REF: 31 St Mark's Crescent, NW1 - Revised BIA Notification (2017/1534/P)

We object strongly to the proposed sub-basement at 31 St Marks Crescent. Our three main reasons for this are:

Figure 16. Approximate widths and distances of adjacent structures (Not to Scale)

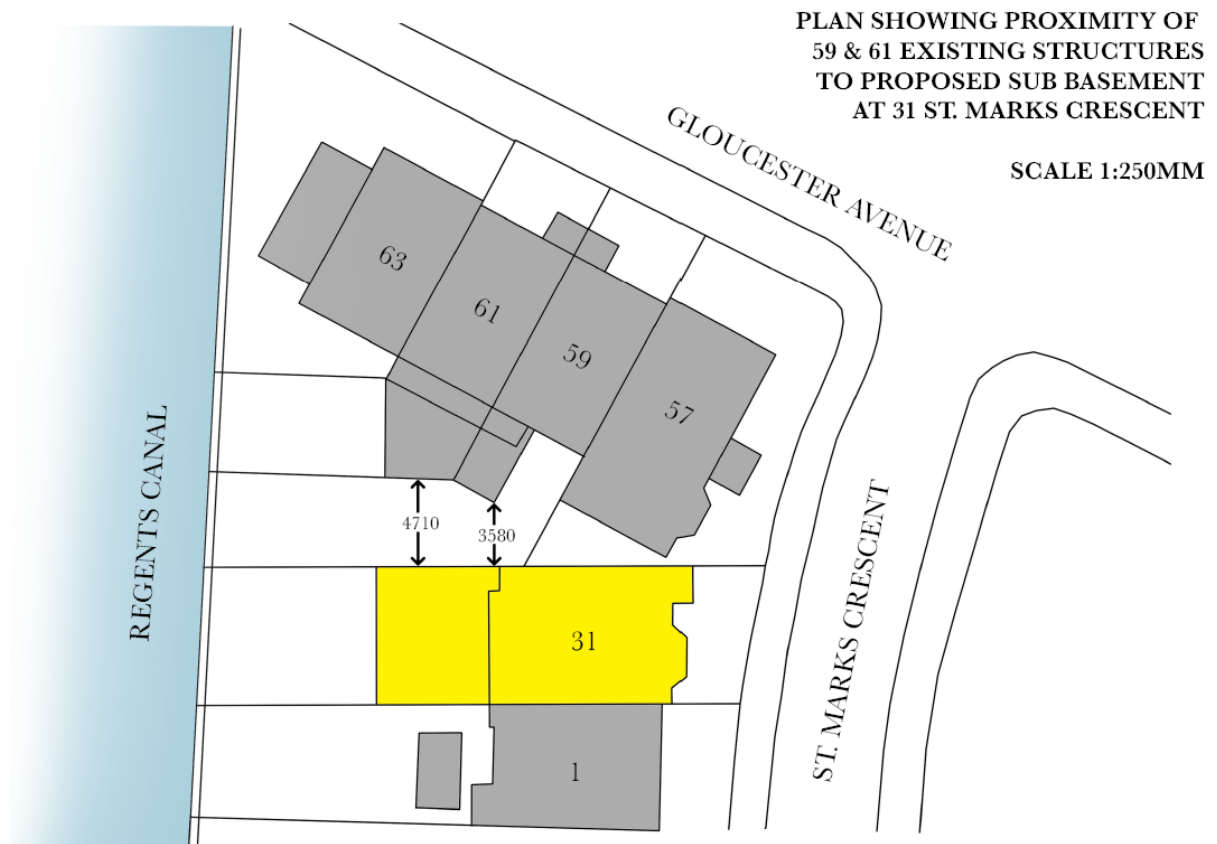
Our rear extension at 59 is only 3.5m from the proposed 4m deep excavation. On Chelmer's fig 16 they have omitted to show our extension as a solid (grey) structure. It has been present for over 50 years.

Figure 16, page 28: this is drawn not to scale. It fails to show the brick extension to my mother’s house that has been present over 50 years, with glass doors, and is within 3.5 metres of the proposed basement.
